CONFIRMATORY SAMPLING WORK PLAN AREA OF CONCERN 726 (AOC 726) ZONE H  
CNC CHARLESTON SC  
6/8/2006  
SOUTH CAROLINA DEPARTMENT OF HEALTH AND ENVIRONMENTAL CONTROL

RE: Approval  
Confirmatory Sampling Work Plan, AOC 726, Zone H, Revision 1  
Charleston Naval Complex (CNC)  
SC0 170 022 560

RE: Comments  
Confirmatory Sampling Work Plan, AOC 726, Zone H  
Charleston Naval Complex (CNC)  
SC0 170 022 560

**Responses to SCDHEC Comments on the  
Revision 0 CSWP**

**Figure 4-1**  
Proposed Soil and Groundwater Sampling Locations  
ADC 726 CS Work Plan  
Charleston Naval Complex

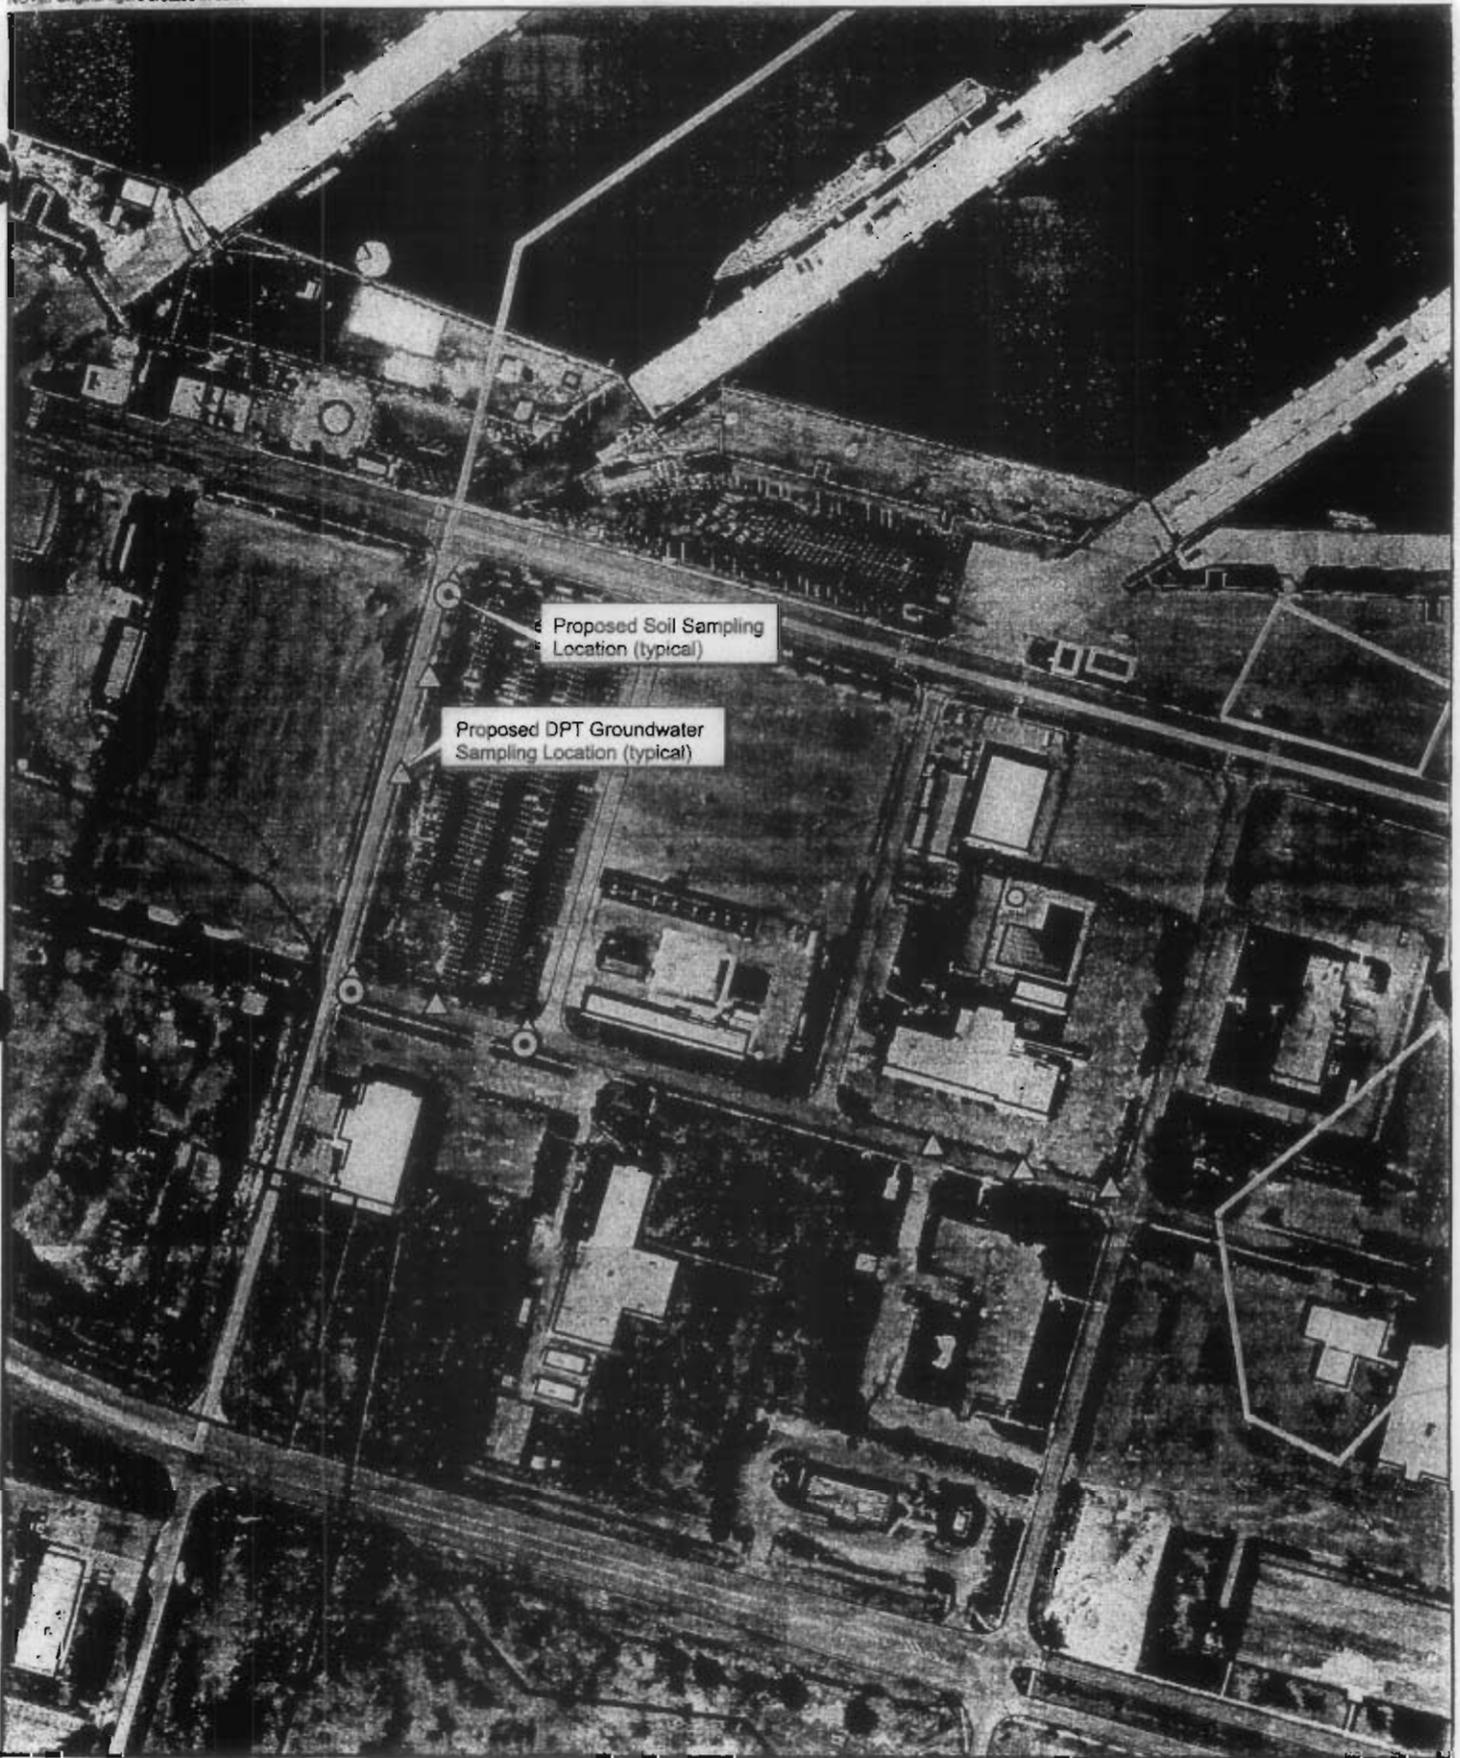
A) This section proposes the collection of seven (7) groundwater samples at the locations shown on Figure 4-1. However, Figure 4-1 indicates eight (8) proposed locations. The Figure or the text should be revised to include the actual number of proposed sampling locations.

B) No groundwater samples are currently proposed in the area near Manhole 8. The proposed groundwater sampling locations should be revised to include sampling near Manhole 8, and Figure 4-1 should be revised to include these new locations.

A) This section proposes the collection of seven (7) groundwater samples at the locations shown on Figure 4-1. However, Figure 4-1 indicates eight (8) proposed locations. The Figure or the text should be revised to include the actual number of proposed sampling locations.

B) No groundwater samples are currently proposed in the area near Manhole 8. The proposed groundwater sampling locations should be revised to include sampling near Manhole 8, and Figure 4-1 should be revised to include these new locations.

**Groundwater sampling locations will be added at manholes 7 and 8. A total of 9 groundwater samples will be collected and analyzed.**

**Figure 4-1 inadvertently included an extra groundwater sampling location along Halsey Street between manhole 6 and the entrance to the U.S. Coast Guard long-term parking lot. The figure will be revised to show the new sampling locations.**
